**Waipawa Streets for People**

**Detailed Design Stage Safe System Audit Report**  
**Prepared for Central Hawke's Bay District Council**

REVISION 0 – MARCH 2024

Figure 5.4-1 – Proposed southern threshold treatment

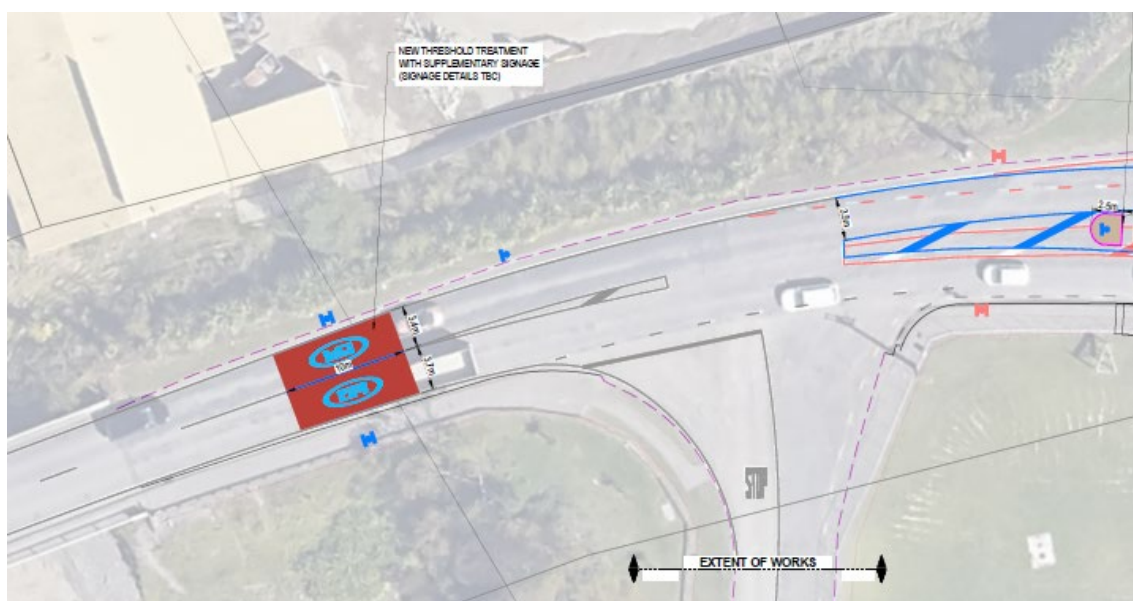
An updated threshold treatment has been proposed at the south end of the project extent. This includes additional / updated threshold (speed) signage and coloured surface pavement markings to reinforce the speed limit and attempt to control speeds of entry to the proposed roundabout. The updated design is shown in Figure 5.4-1.

The plans provided do not have further information or details around the type of surfacing / paint to be used. The SAT are concerned if the incorrect product is applied, it can be a hazard to some road users, including cyclists, and in particular, motorcyclists. There are also maintenance considerations which in turn lead to safety in design decisions around the type of product, maintenance intervention, traffic control etc. The same comment applies to the proposed treatment at the northern threshold.

1. Confirm pavement surface markings to be used at the thresholds, and confirm they consider the safety of motorcyclists

Figure 5.4-2 – Proposed southern pedestrian refuge

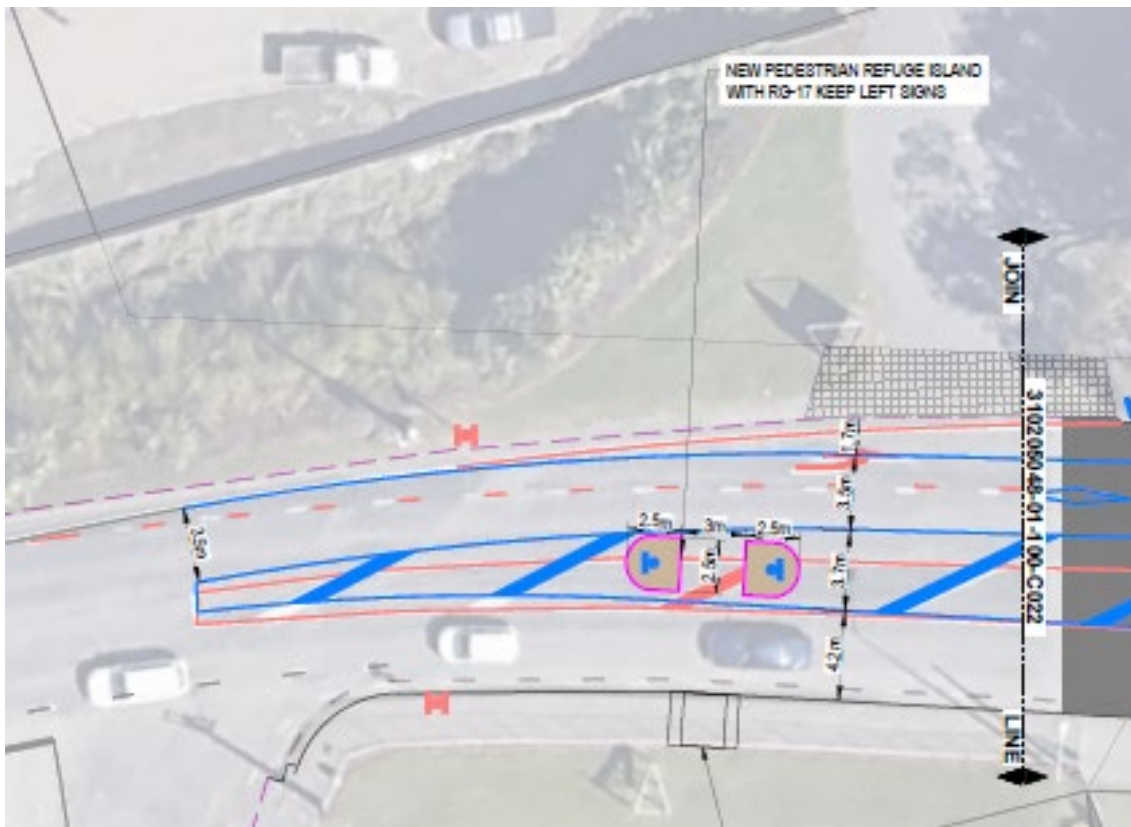
The plans provided show a new pedestrian refuge proposed between Harker Street and Ruataniwha Street, as shown in Figure 5.4-2. Following meetings and correspondence with CHBDC, it has been decided this will be replaced by a mountable island only. The reasoning for this is to help with deflection and approach speed to the roundabout proposed at Ruataniwha Street. For pedestrians, this will mean the crossing point in this location will not be promoted, but the island can be used for those that decide to cross in this location.

The SAT have the following concerns:

- It is unclear as to the pedestrian volumes and desire lines in this location (i.e. there was previously a need for the crossing here with this shown in earlier schemes)
- If pedestrians are not actively encouraged or forced to the BP crossing point, they will continue to cross in this location.
- Overall connectivity of the pedestrian crossing within the area is poor (see Audit Point 5.4.4)

1. *Confirm pedestrian desire lines and volumes for this location*
2. *Consider improvements to this crossing location (even if temporary i.e. by use of removable kerbs etc) if desire lines are strong*
3. *Consider further measures to encourage crossing at the BP facility*

Figure 5.38 – Harker Street, Desire line

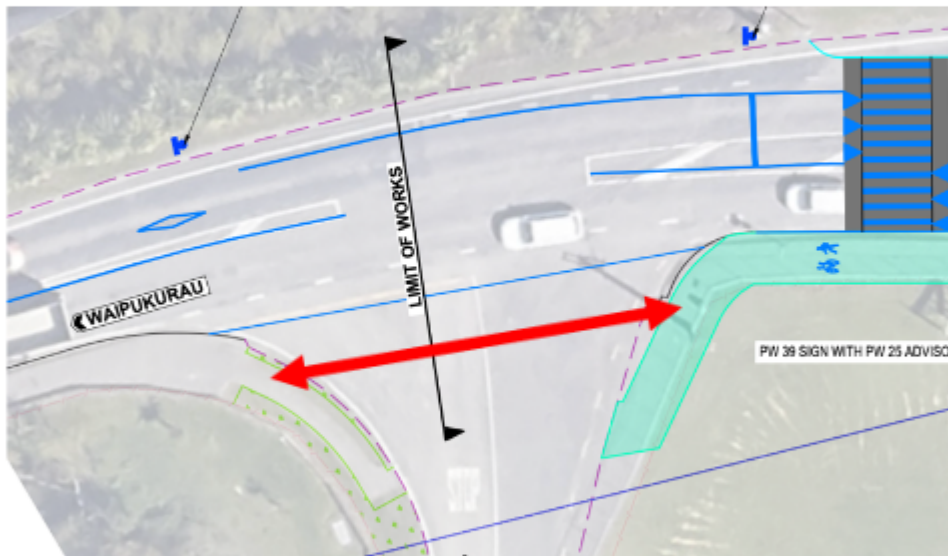
The project finishes immediately prior to the Harker Street intersection. To the south of this is the Waipawa River Bridge which as discussed in Section 5.3.1 leads to the Waipawa to Waipukurau shared path. The SAT believe changes to the Harker Street intersection should be included as part of the Streets for People project.

The natural desire line is across the throat of the intersection. Users are likely to cross here whether there are facilities or not. The installation of a splitter island with a refuge would provide benefits for users to provide protection and a two part crossing. It is understood that there are potential changes to the use of Harker Street which may allow this crossing point to be designed differently. It is recommended that this be taken into consideration as part of this project to improve connectivity.

1. Include this intersection within the project scope and introduce facilities to improve the safety and level of service for pedestrians and cyclists.

<b>Probability Rating:</b> The probability of a crash is N/A	<b>Severity Outcome Rating:</b> Crashes are likely to be N/A
<b>Design Team Response:</b> This was discussed with CHBDC and WK project representatives on 26/4/2023. It was advised to consider a splitter island on Harker Street. Design will be updated to include a splitter island.

Figure 5.312 – Pedestrian demand across Kenilworth Street

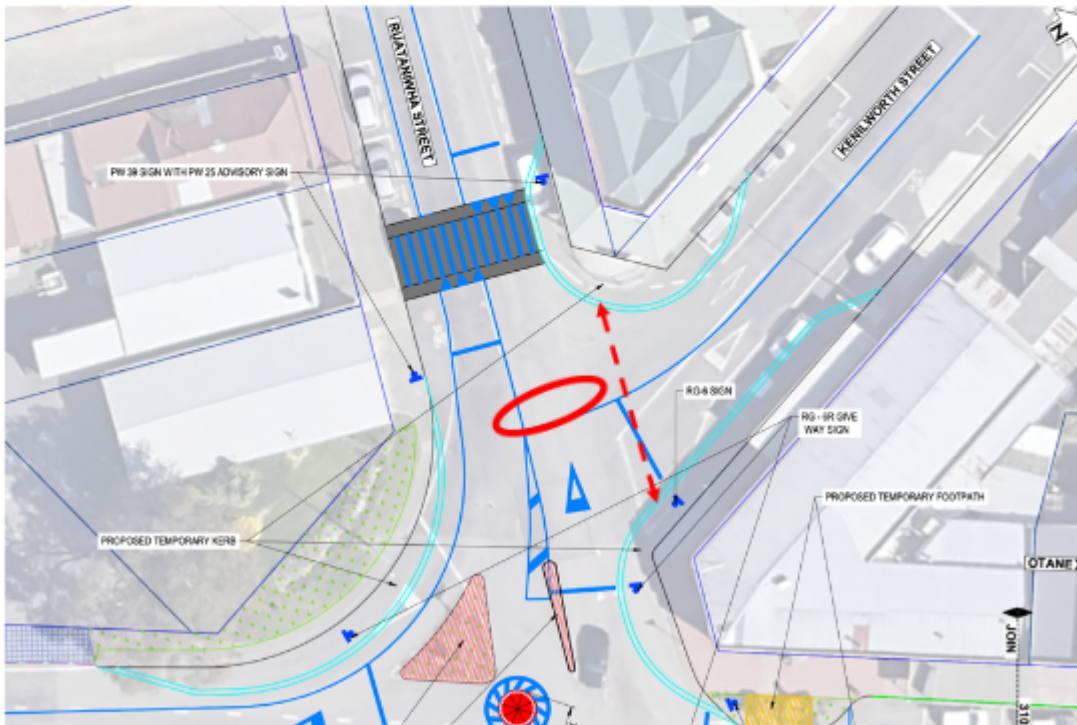
The design does not include any pedestrian facilities across Kenilworth Street. The SAT is aware of there being reasonable pedestrian demand across this intersection. The angle of entry of Kenilworth Street makes this a wide intersection for pedestrians to cross. There is a risk in particular to older, disabled and young vulnerable users trying to cross this wider section of road. Due the nature of the users any injuries will be serious.

Consideration should be given to providing improved pedestrian facilities across this intersection.

There is a non-standard line, circled in Figure 5.3.12, which is assumed to be a draughting error.

1. *Confirm pedestrian demand and desire lines for the project extents*
2. *Confirm crossing facility for Harker Street (previous audit agreed this would include a splitter island)*
3. *Confirm crossing facility for Kenliworth Street (previous audit agreed this would be provided further north of the existing crossing)*
4. *Confirm proposed crossing facility across Ruataniwha Street*

Figure 5.4-3 – Proposed new SH2 Roundabout

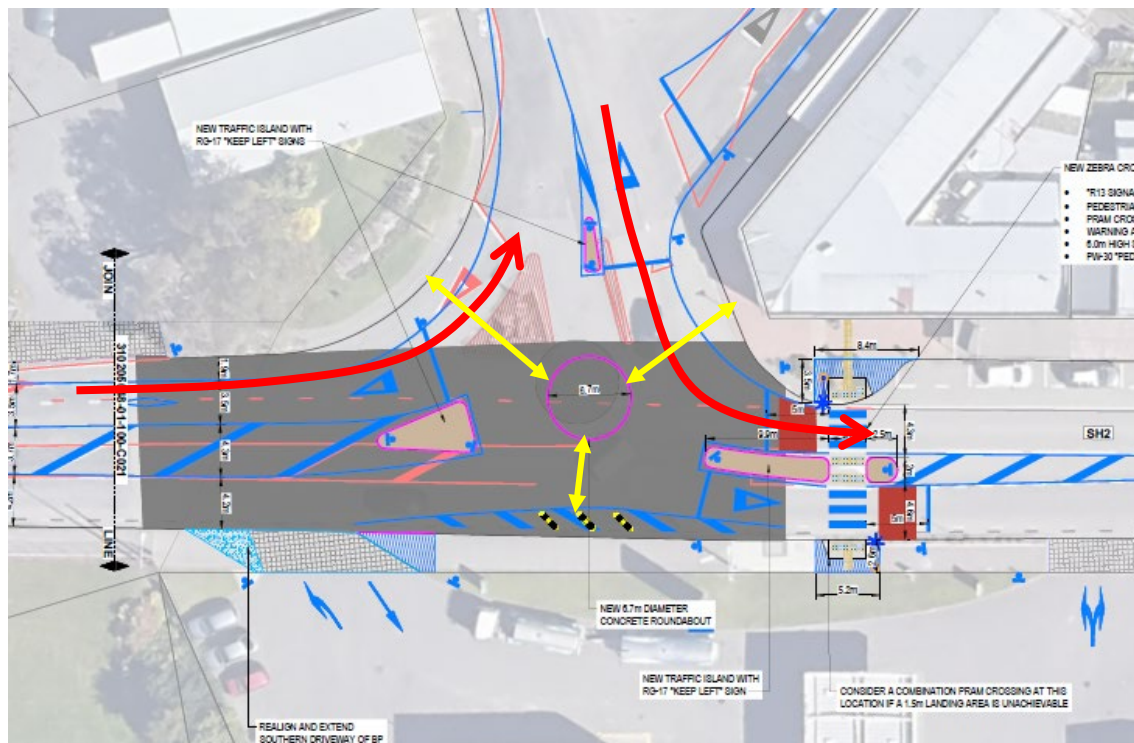
A new roundabout is proposed at the intersection of SH2 and Ruataniwha Street. There have been some modifications to the previous preliminary design stage. Refer to Figure 5.4-3.

Tracking has not been provided at earlier stages or with the latest design update. The SAT are concerned the roundabout has not been considered for tracking of design vehicles and for all turning movements. For example, there are shoulder pavement markings and speed humps provided on the west side of the intersection (outside BP) to provide some deflection and road narrowing in the southbound direction. However, there are no such markings for the left turn into and left turn out of Ruataniwha Street (shown marked in red in Figure 5.4-3). In particular, the width of existing pavement for the left turn in movement appears to be much wider than other legs of the roundabout (refer to yellow arrows in Figure 5.4-3).

Furthermore, it is unclear whether the central island will be trafficable. There are no details provided around typical details for the roundabout including material (kerb and channel etc); markings and signage. The SAT consider a larger roundabout may be more appropriate in this location to balance out the deflection and speeds of most vehicles, versus the larger tracking required for a heavy vehicle. Higher speeds through the roundabout will increase the severity of any crashes.

One recommendation is to mark a larger roundabout with pavement markings and / or provide a trafficable surface for larger vehicles, where required. Given the nature of the project being experimental in some elements, a temporary roundabout may be considered for monitoring and then adjusted and made more permanent following review of the tracking and overall performance.

1. Provide tracking paths for the roundabout and modify markings to suit
2. Confirm details of the central island
3. Consider additional pavement markings (i.e. shoulder bars) and / or speed bumps (armadillos) on the left turn in and out movements at Ruataniwha Street

**Figure 5.4-4 – Line marking adjacent to the proposed roundabout**

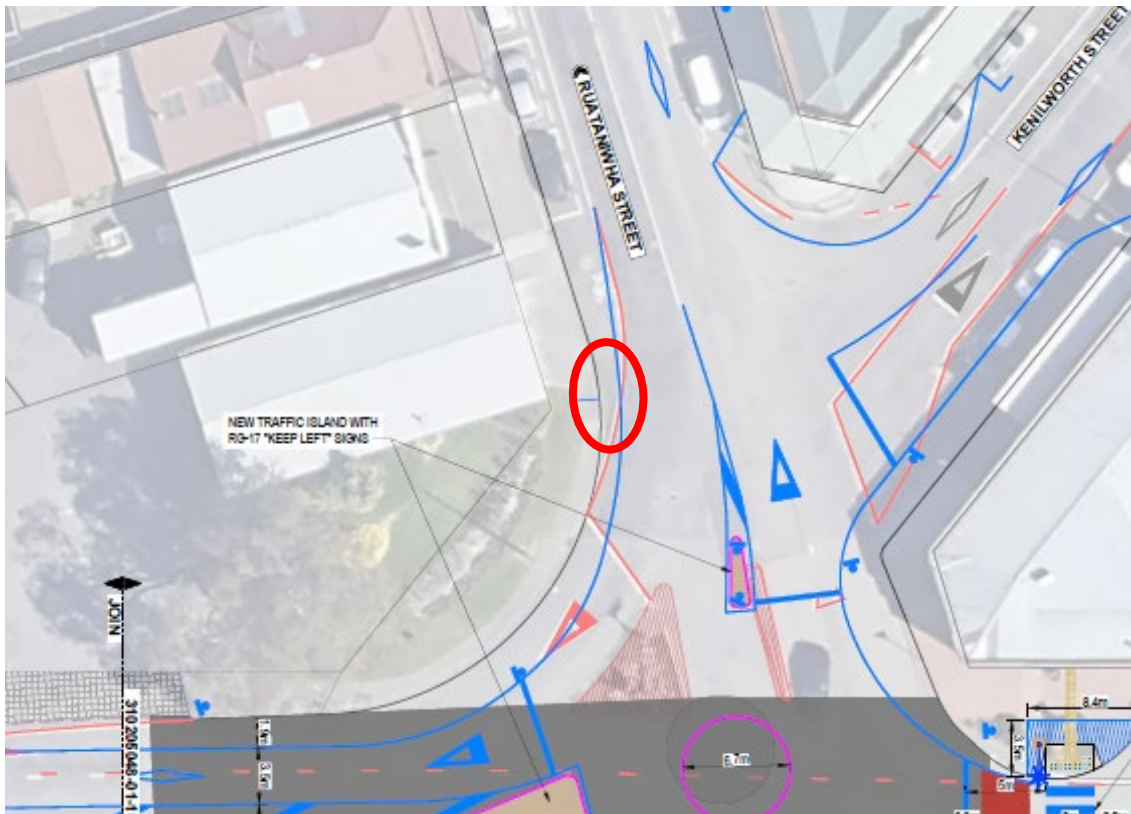
The design includes an edge line adjacent to the south-west corner of the roundabout. This was raised in the previous design stage audit. This edgeline alters in width through the curve that may make cyclists have a false sense of security as there appears ample shoulder space (approx 2.0m), before narrowing to less than 1.0m (approximated from the plans). There is a high risk of cyclists being struck in this pinch point by heavy vehicles negotiating the roundabout. This is likely to result in death or serious injuries.

Consideration should be given to smoothing this line and / or provided a marked area separating the traffic lane (and area used for tracking) and the shoulder area where a cyclist will ride.

1. *Provide a consistent marked shoulder width for cyclists*
2. *Consider a marked area separating the traffic lane and shoulder to provide additional space for cyclists*

**Figure 5.4-5 – Proposed new pedestrian crossing**

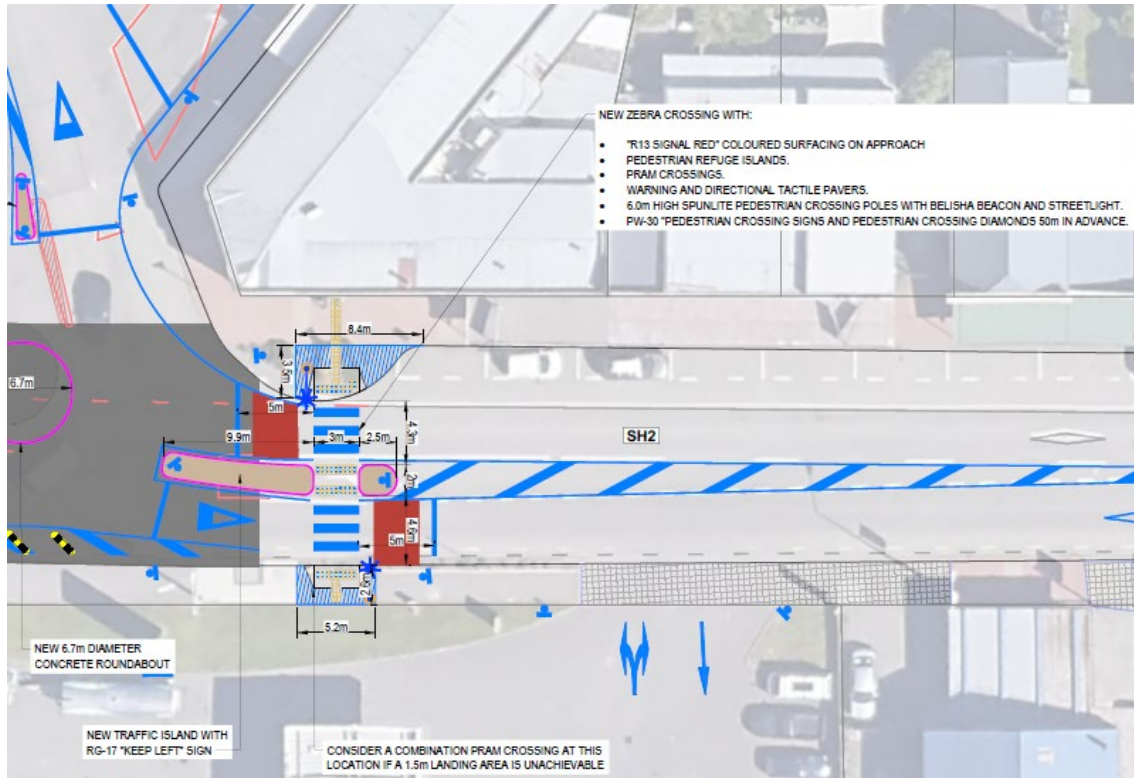
A new formal pedestrian crossing (zebra) is proposed across SH2, outside BP as shown in Figure 5.4-5. This was previously a raised safety platform but is now proposed to be at grade. The SAT also understand the traffic islands shown will be removed to reduce confusion and compliance with pedestrians potentially crossing in two movements.

The SAT raise the following concerns / comments:

- A raised safety platform helps to reduce speeds to within safe system tolerances i.e. less than 30 km/h for pedestrians and cyclists
- The traffic islands also help control speeds on approach to the crossing (and roundabout) by physically narrowing the road
- The traffic islands also help with the alignment / entry deflection for approaching vehicles to the intersection
- There is some concern that a southbound vehicle may enter into the flush median (with the islands removed) and attempt to turn right from this position. They may not notice the zebra crossing and / or approach the crossing at high speed, placing users on the crossing at higher risk

The SAT note that RSP's have been removed from scope due to other, outside reasons. However, they are a preferred treatment and safe system intervention as they reduce speeds and thus impact forces should a crash occur. If RSP's cannot be implemented at the current time on this project, then it is highly recommended that all other measures are to the highest standard for visibility of the crossing, i.e. high quality markings and signage and other measures are considered to control approach speeds e.g. vertical elements to provide visibility and assist with traffic calming.

1. Provide a safe system solution i.e. raised safety platform at the crossing
2. Confirm if the islands are to be removed. If so, then provide supplementary treatments to help control speeds and increase the prominence of the crossing e.g. physical / vertical separators
3. Provide red markings across SH2 to increase prominence
4. Provide all other pavement markings and signage that meet current standard
5. Confirm lighting for the crossing

Figure 5.4-6 – Proposed new pedestrian crossing outside Butchery

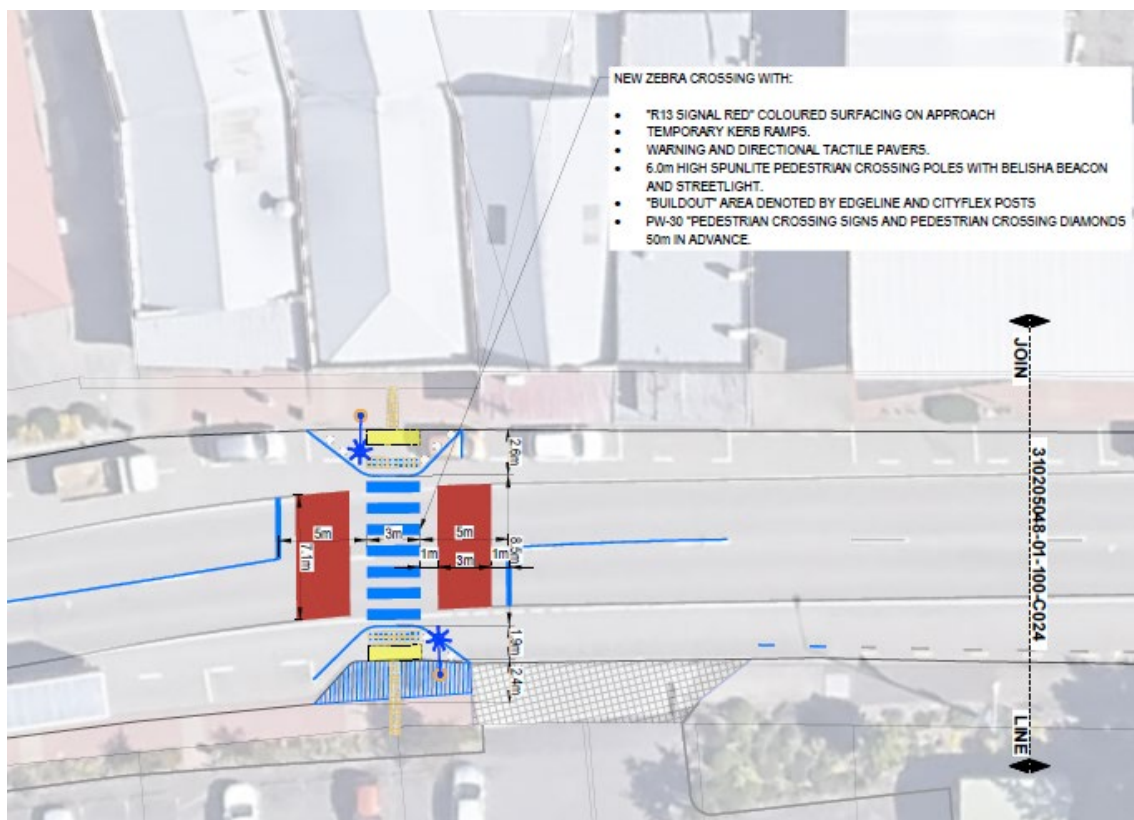
A new formal pedestrian crossing (zebra) is proposed across SH2, outside the butchery as shown in Figure 5.4-6. This was previously a raised safety platform but is now proposed to be at grade.

The SAT raise the following concerns / comments:

- A raised safety platform helps to reduce speeds to within safe system tolerances i.e. less than 30 km/h for pedestrians and cyclists
- There is some concern with the design of the kerb build outs on either side of SH2. It is unclear from the design plans, but the kerb and channel appears to extend into the road shoulder where cyclists will be riding. This creates a pinch point for cyclists and they may be struck by an adjacent vehicle in the traffic lane

The SAT note that RSP's have been removed from scope due to other, outside reasons. However, they are a preferred treatment and safe system intervention as they reduce speeds and thus impact forces should a crash occur. If RSP's cannot be implemented at the current time on this project, then it is highly recommended that all other measures are to the highest standard for visibility of the crossing, i.e. high quality markings and signage and other measures are considered to control approach speeds e.g. vertical elements to provide visibility and assist with traffic calming.

1. Provide a safe system solution i.e. raised safety platform at the crossing
2. Confirm the design for the kerb build outs. Provide additional space for on-road cyclists
3. Confirm lighting for the crossing
